MEETING NOTES

Meeting Date: Friday, July 28th, 2017 – 10:30–11:30am
DFD Project Number: 14I2O
Project: Wittich Hall Renovation
Location: Wisconsin Historical Society – 816 State Street, Madison, WI 53706
Purpose: Wittich Hall – Historical Review Meeting
Prepared by: Michael Eberle, AIA

WITTICH HALL

THIRD FLOOR WINDOWS

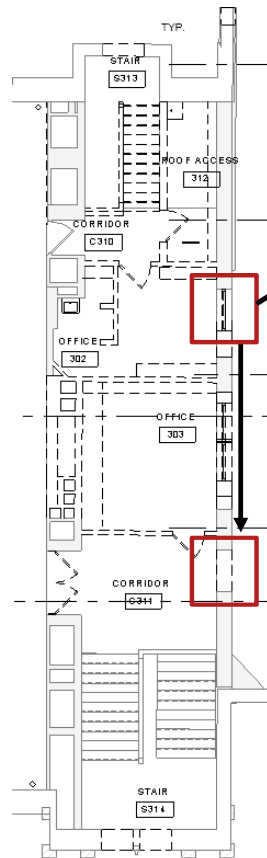
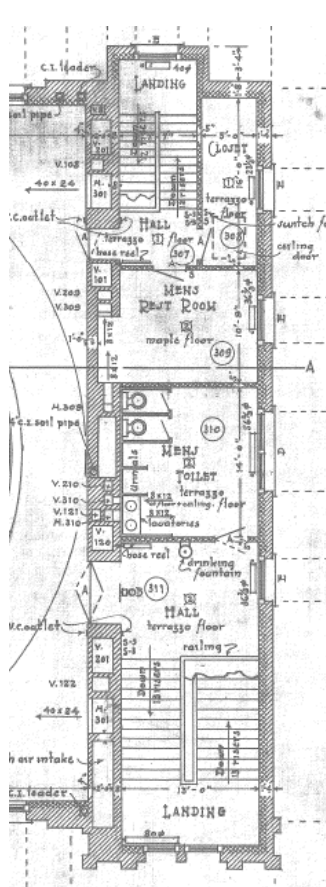
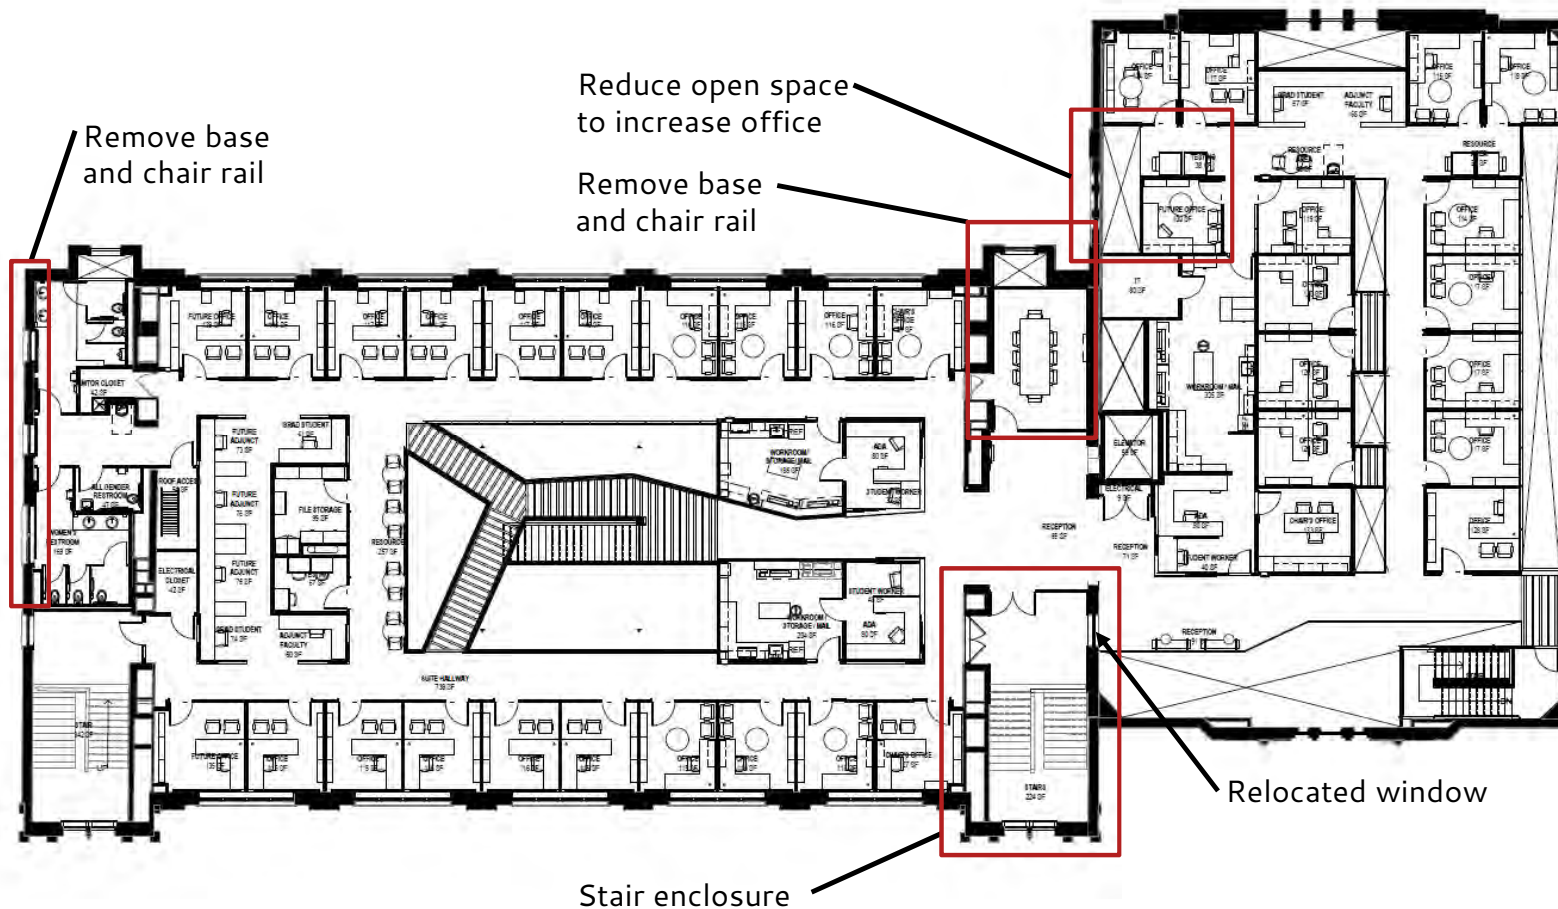
- a. The group discussed moving the single existing window from its current location in room 302 to a previous location where a similar size window existed in the stair.
- b. Moving the office wall approximately 1 foot (creating a 4 foot wide double height opening) was deemed ok in the 1930 wing north location.
- c. The groups discussed removing the existing wall grilles from the radiator niches in the exterior walls of the 1930 and 1916 wings.
 - i. Removing the 1916 wing grilles and filling with a blank-off or other material was noted as being acceptable.
 - ii. The grilles in the 1930 wing are in brick and located in the history display zones on the west and south walls. Jen thought we could have more flexibility with what goes back into these opening or if they are left as recesses and something else incorporated.

Relocate window to previously blocked up location

Brick Allowance:

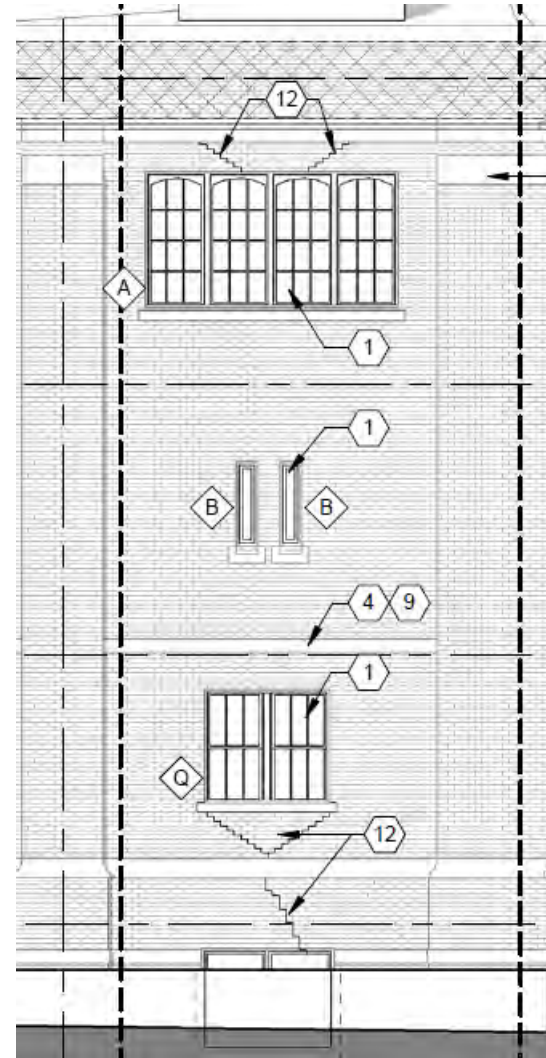
- a. Cleaning / Pointing
 - i. All brick (interior and exterior) is planned to be cleaned.
 - ii. 40% of the brick is currently planned to be pointed.
- b. New Brick
 - i. The group discussed the need to define allowances for new brick and additional pointing. **Action: Aro Eberle / River Architects**
 - ii. It was noted that Mike will have several brick suppliers visit the site and try to match color and texture. **Action: River Architects**
 - 1. It was noted that an exact match may not be possible, but will get close.
 - 2. Brick match will need to be approved by DFD and UWL.
 - iii. New brick on the trash enclosure will match the other enclosures being installed on campus and not match the building.
- c. Brick Repairs
 - i. Stepped cracks are being documented on the elevations.

Contractor bid to include allowance for 500(?) replacement brick for fractured units that are deemed unsalvageable. Replacement brick to be used where MEP items are removed.

EXTERIOR RESTORATION/REHABILITATION - WALLS

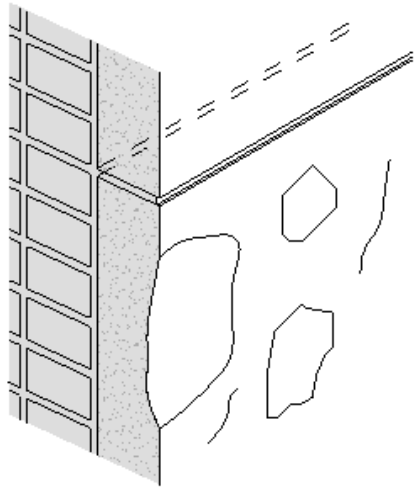
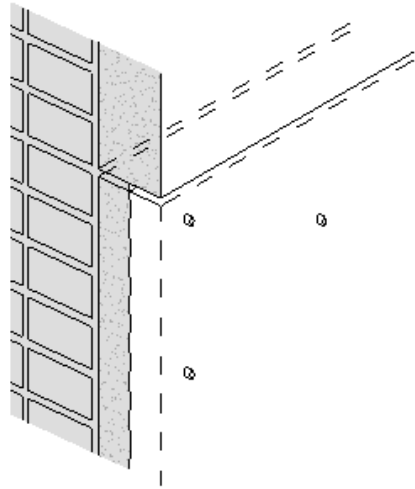
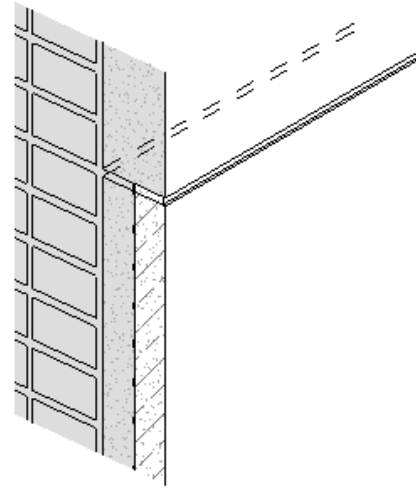
- a. Mike reviewed areas and details for replacing the 2" facing of several damaged stones at the northwest entry.
- b. Mike described a Jahn mortar patching product that they have used successfully for repairing areas where stone has spalled.
 - i. Mike noted successful experience Bonstone out of Mukwonago.
 - ii. Epoxy bond is very strong and color match is nearly exact.

DETAIL STEP 1:
REMOVE 2" MIN. FROM STONE
PANEL FACE

DETAIL STEP 2:
INSTALL 1/2" SS BOLTS EPOXY
SET INTO STONE AND MASONRY
BACKUP

DETAIL STEP 3:
PROVIDE HOLE DEPRESSION
AT BACK OF NEW STONE PANEL
FOR SS BOLTS TO RECESS INTO

DETAIL STEP 4:
INSTALL SHIMS AT BOTTOM OF
PANEL TO PROVIDE
TEMPORARY SUPPORT DURING
SETTING PROCESS

DETAIL STEP 5:
APPLY EXPOXY ADHESIVE TO
BACK OF STONE PANEL - SET
INTO PLACE - ENSURE 100%
COVERAGE - REMOVE AND
INSPECT UNTIL COVERAGE
REQUIREMENT HAS BEEN MET

2 NEW ROOF/PARAPET DETAIL
1 1/2

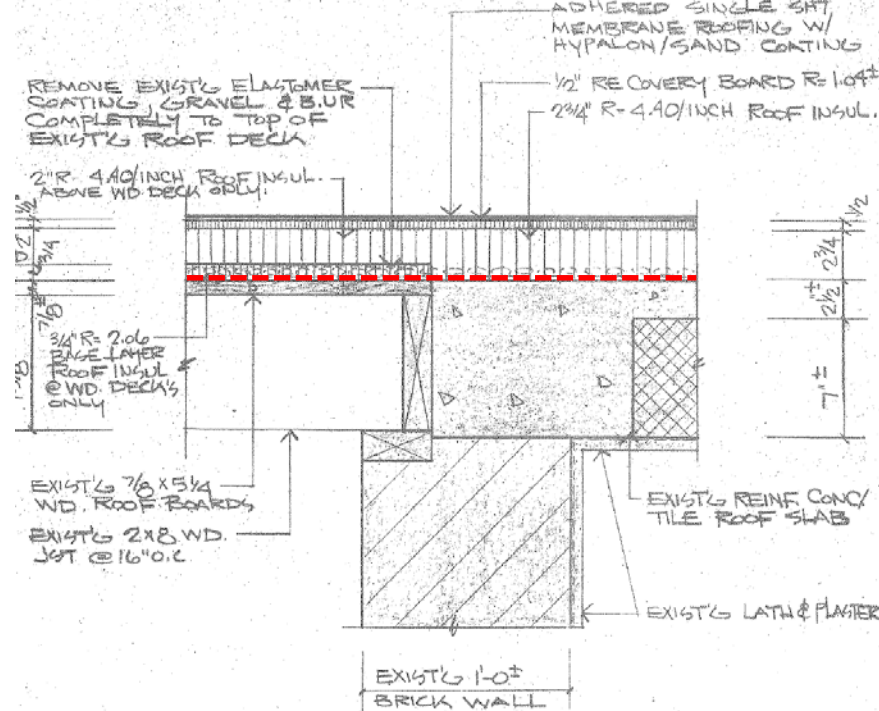
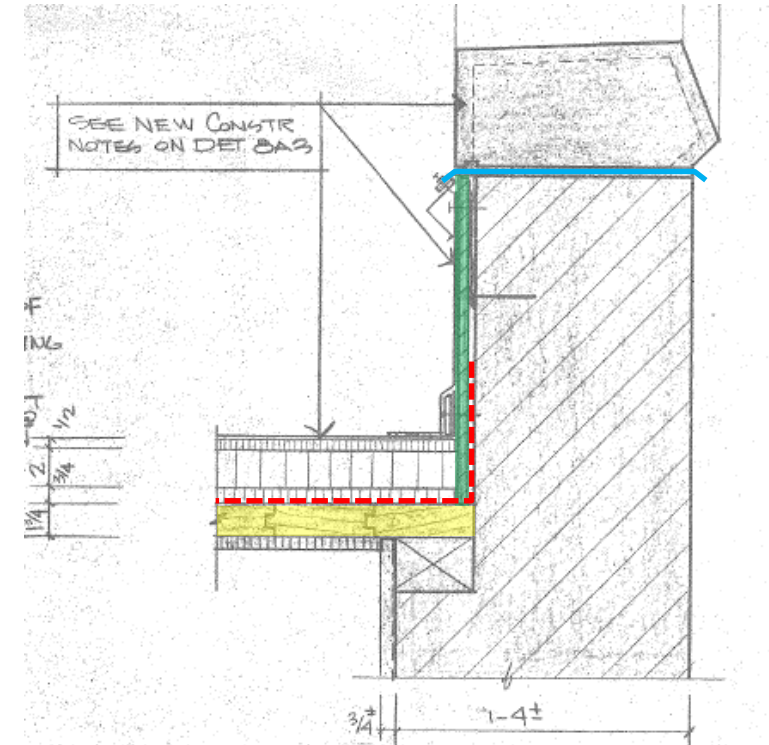
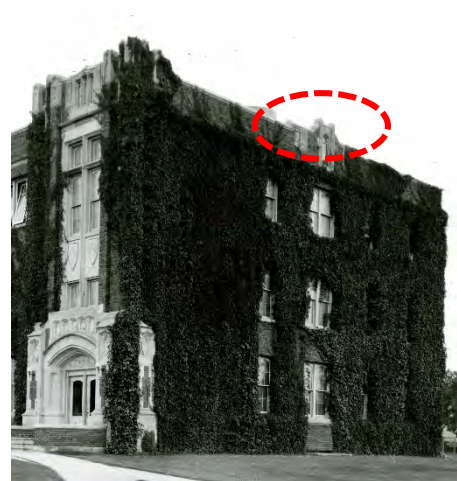
- a. Core samples of insulation thickness are being scheduled by campus. **POST MEETING NOTE: Data from sampling was received via email on 8/10/17.**
- b. Area of existing limestone coping at the south end of the 1916 wing is adjacent to the new mechanical penthouse and was recommended by our envelope consultant to be removed and flashed over due to concerns of snow drifting. The group agreed to removing and flash over the top. Coping could be salvaged and incorporated into the historic display.

- c. Existing coping stones (and mortar joints) are in good shape and were previously discussed as being removed and new flashings installed under. Per discussions with DFD the coping stones will remain and no new flashing installed. Coping will be cleaned and joints reworked as needed.

- d. Existing insulation thickness was discussed and a minimal amount of new insulation will be added. Insulation thickness will be driven by flashing requirements.

- Insulation thickness ranges from 2" to 2 3/4" (4" min. recommended). Challenges with vertical height at various parapets.
- 1930 Gymnasium has 1 3/4" structural wood decking that was originally exposed and has since been covered (highlighted in yellow).
- Verification needed if plywood sheathing was installed at back of parapets as detailed (highlighted in green).
- Installation of vapor barrier membrane will be included in roofing work (shown in red) along with flashing beneath stone coping
